**City of Portland, Maine – Building or Use Permit Application** 389 Congress Street, 04101, Tel: (207) 874-8703, FAX: 874-8716

Location of Construction: **174 Curtis Road 04103		Owner: Charles & Jennifer Hull		Phone: 876-1999		Permit No: <b>990568</b> <b>PERMIT ISSUED</b> Permit Issued: <b>JUN 8 1999</b> <b>CITY OF PORTLAND</b> Zone: CBL: 389-G-025	
Owner Address: SAA		Lessee/Buyer's Name:		Phone:			Zoning Approval: OK with conditions <b>Special Zone or Reviews:</b> <input type="checkbox"/> Shoreland <input type="checkbox"/> Wetland <input type="checkbox"/> Flood Zone <input type="checkbox"/> Subdivision <input type="checkbox"/> Site Plan maj <input type="checkbox"/> minor <input type="checkbox"/> mm
Contractor Name: Owner		Address:		Phone:			
Past Use: 1-Family		Proposed Use: Same		COST OF WORK: \$ 500.00 PERMIT FEE: \$ 25.00 FIRE DEPT. <input type="checkbox"/> Approved <input type="checkbox"/> Denied INSPECTION: Use Group: Type: Signature: Signature:			
Proposed Project Description: Construct 10 x 11 deck.				PEDESTRIAN ACTIVITIES DISTRICT (P.A.D.) Action: Approved <input type="checkbox"/> Approved with Conditions: <input type="checkbox"/> Denied <input type="checkbox"/> Signat

Site Plan -

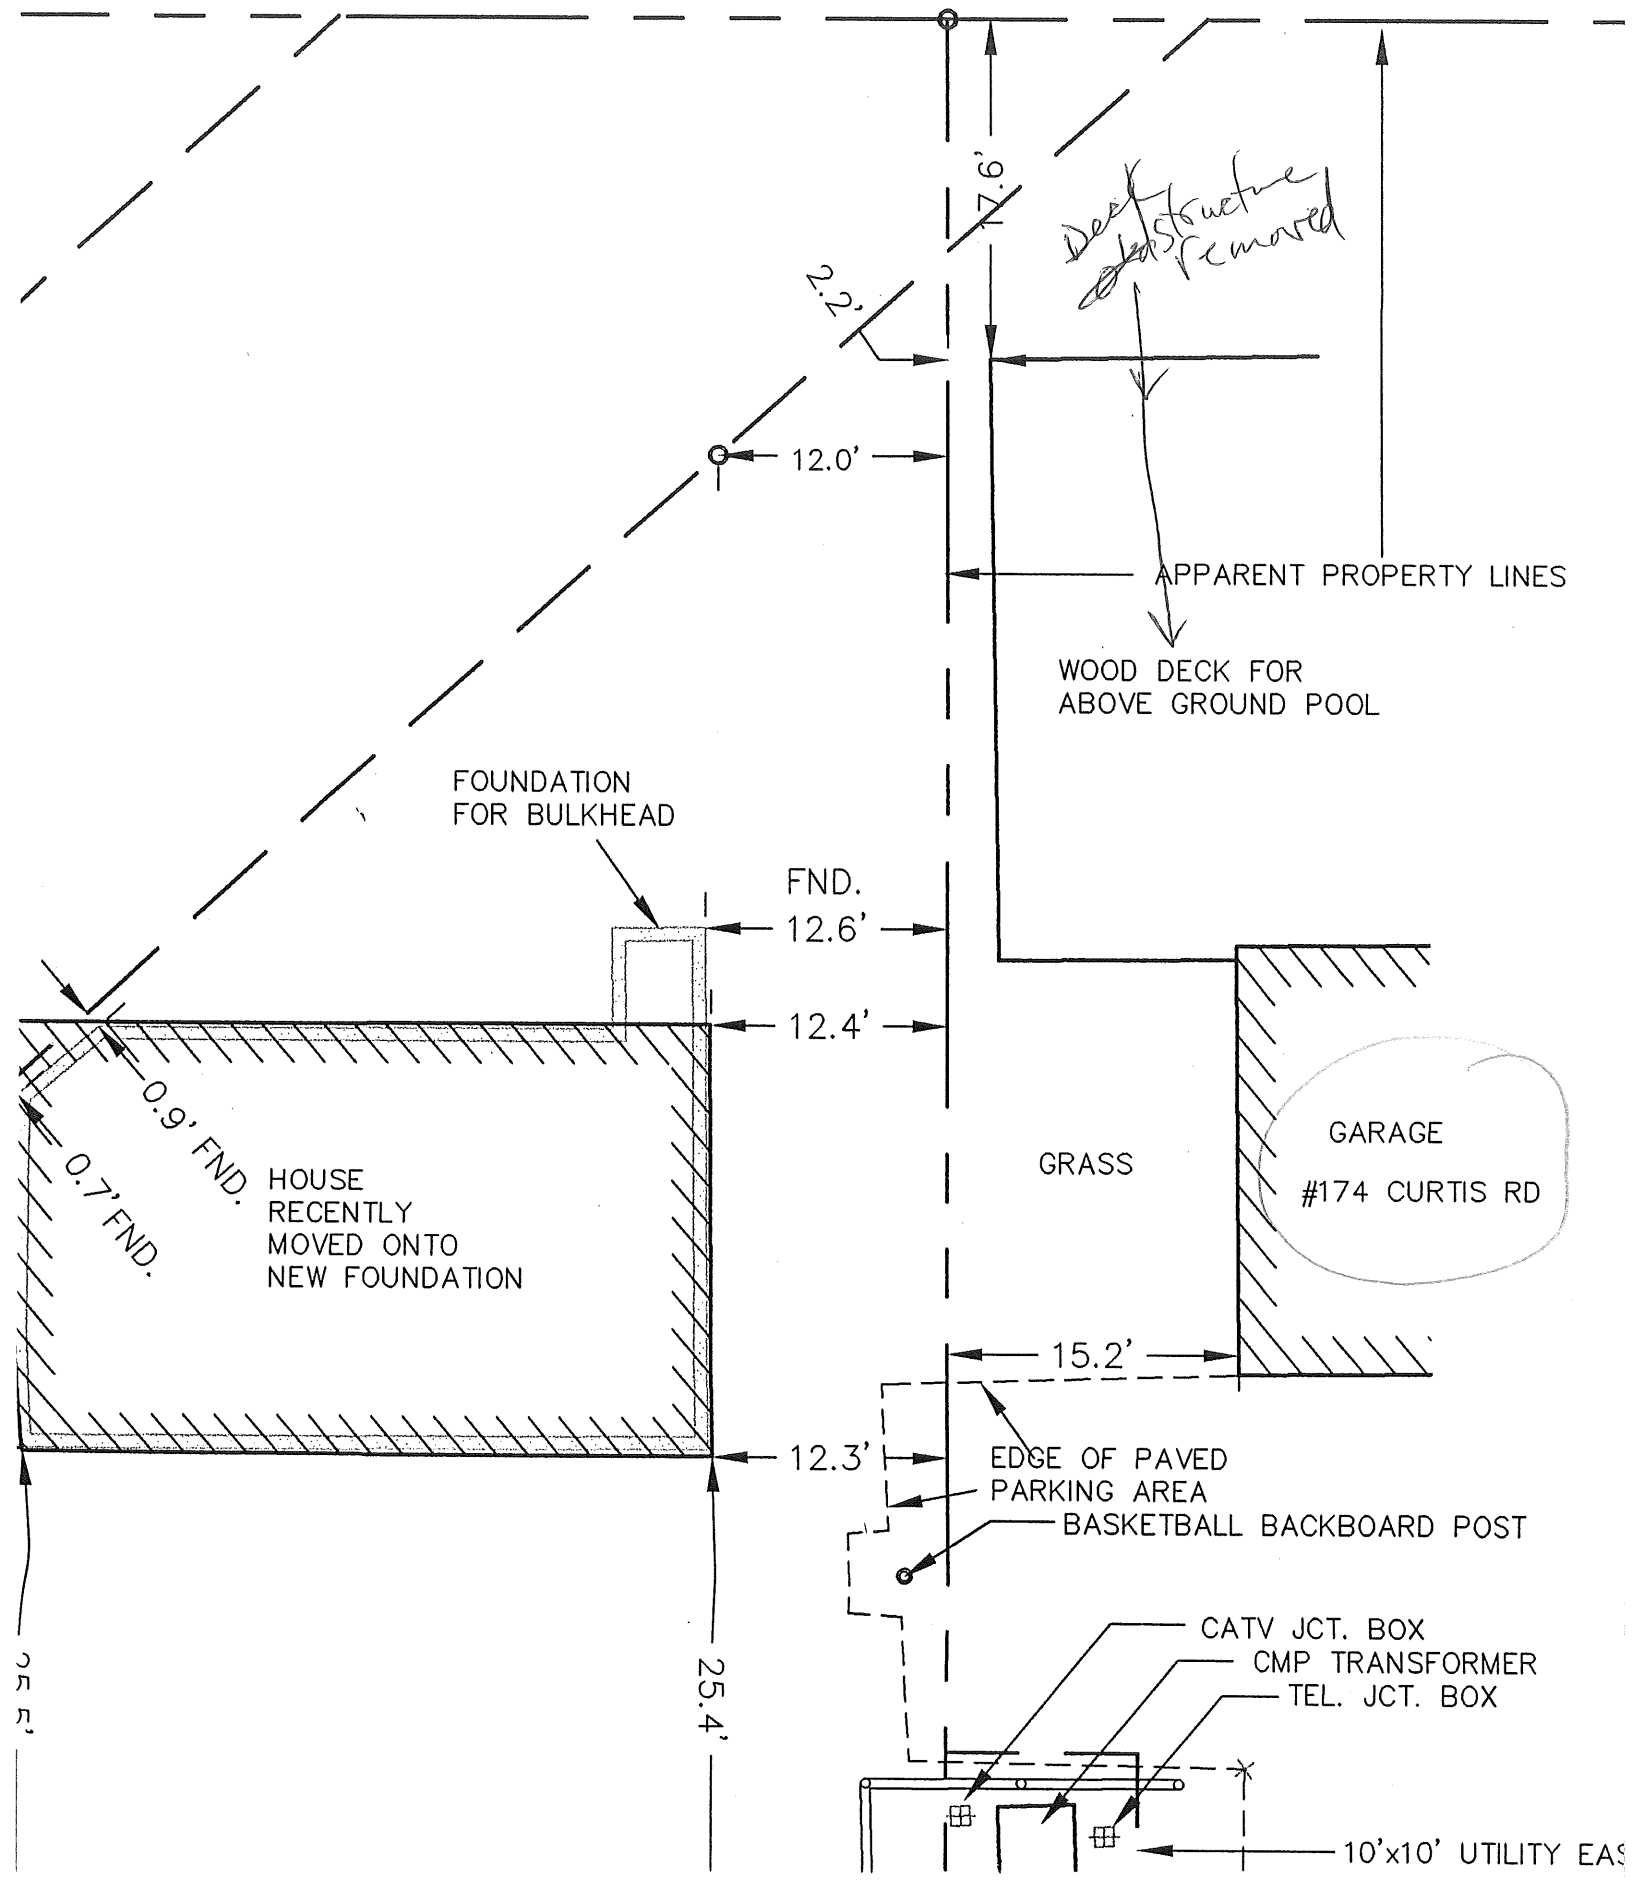
Other requirements of condition your submitted plans were unclear as to the side setback on the left of your property. your deck and any attached stairs shall meet the required setback of 12' from your side lot line

Side Yard - 12' req for 1 story - not clear - will condition 12' req including the stairs

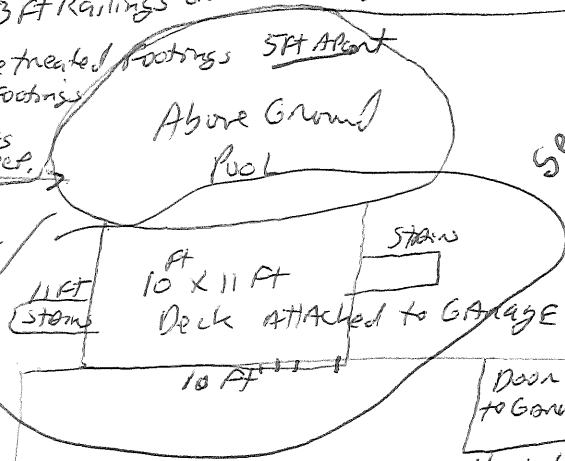
Railings 3 ft high made up of 2x4 Pressure treated wood w/ slots 3" apart made up of 1x2 Pressure treated wood. OK # 1021.2 -

MAX spans 2x8 16" OR 11'-0"  
See STAIR & POOL req.
